Road Safety Audit (Detail Design Stage) Final Report

Keddy Access Trail
Hamilton, Ontario, Canada

March 3, 2020

FIGURE 1: Emergency and Pedestrian Openings

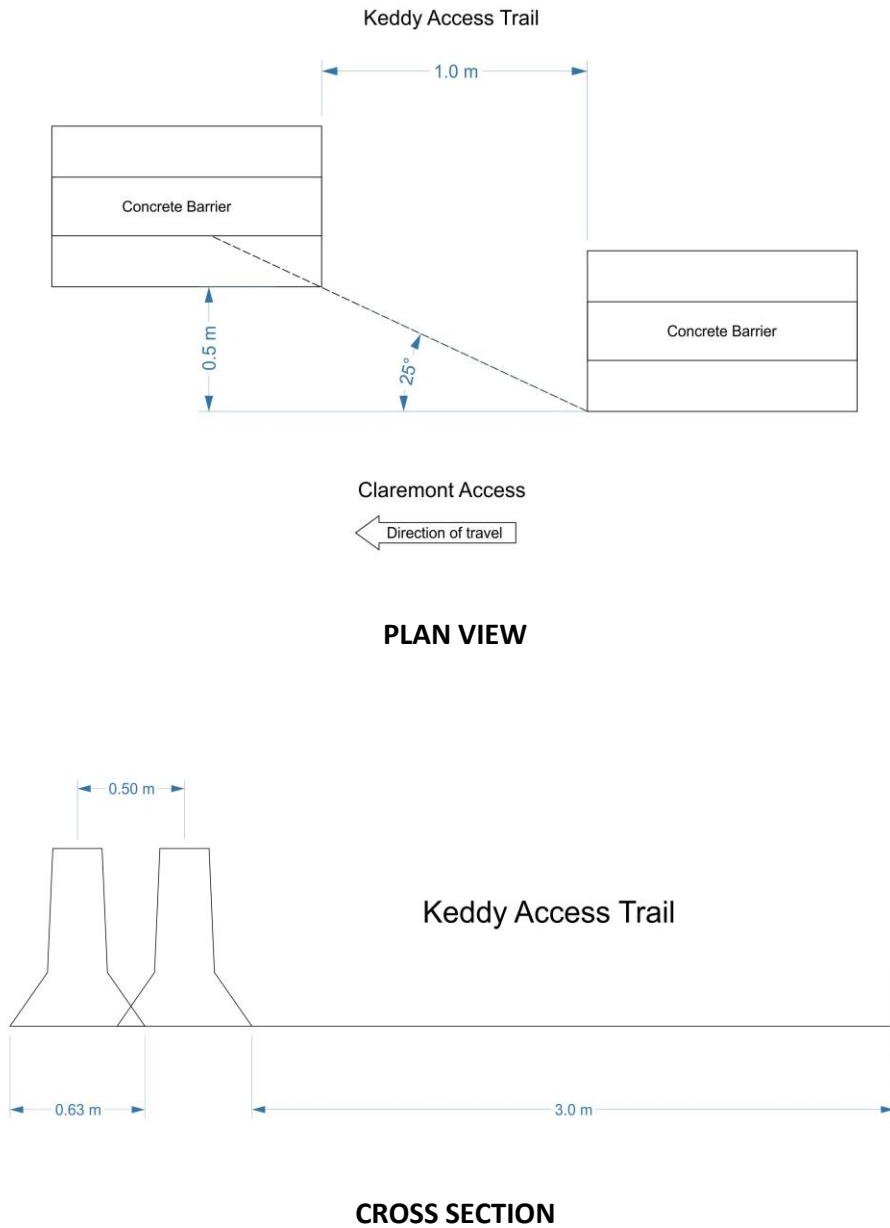
- 2.2.12 Having stated the above, it is noted that the pedestrian crossing located at or near Southam Park requires a short break/opening in the barrier system. Furthermore, it is planned to have other short breaks/openings in the barrier system to accommodate MUT access by emergency services. The breaks/openings will be approximately 1.0 metres wide.

- 2.2.13 The unprotected, blunt end of a concrete barrier is a significant safety hazard to errant road/trail users. If the ends of the barrier cannot be protected by an industry-approved end treatment it is recommended that barriers be offset as shown in Figure 1. Most vehicles will depart the roadway at an angle of 25 degrees or less. Offsetting the downstream barrier effectively shields the exposed end of the downstream barrier with the upstream barrier.

2.2.14 While the offset addresses safety concerns for motorists on the Claremont Access and downbound MUT users, the offset does not address the exposed end hazard for upbound MUT users. However, given the grade of the Keddy Access Trail, operating speeds of upbound MUT users is not expected to be very high. As a result, the risk presented by the exposed end of the barrier is low. No action is required, however, a hazard marker or

similar delineation may be placed in the exposed end to warn upbound MUT users of the existence of the hazard.

- 2.2.15 The barrier offset makes the opening slightly more obvious to upbound MUT users – leading to potential confusion about whether the opening is an allowable route. This is expected to be a minor concern, since the opening is relatively small and the offset still results in the base of the concrete barriers visually overlapping (see the Cross Section in Figure 1). If desired, measures may be taken to minimize the probability of upbound MUT users passing through the opening to the Claremont Access. For example, a directional dividing line and/or edge lines may be marked on the trail from 20 metres in advance of, and through the opening. Also, signing may be used to direct upbound trail users to keep to the right at these locations. Alternatively, if it is acceptable to the emergency services, a movable or breakable horizontal beam or member could be erected across the opening. The beam is intended to be a visual obstruction that discourages MUT users from entering the opening, but not a substantive structural measure that would inhibit emergency services from using the opening.
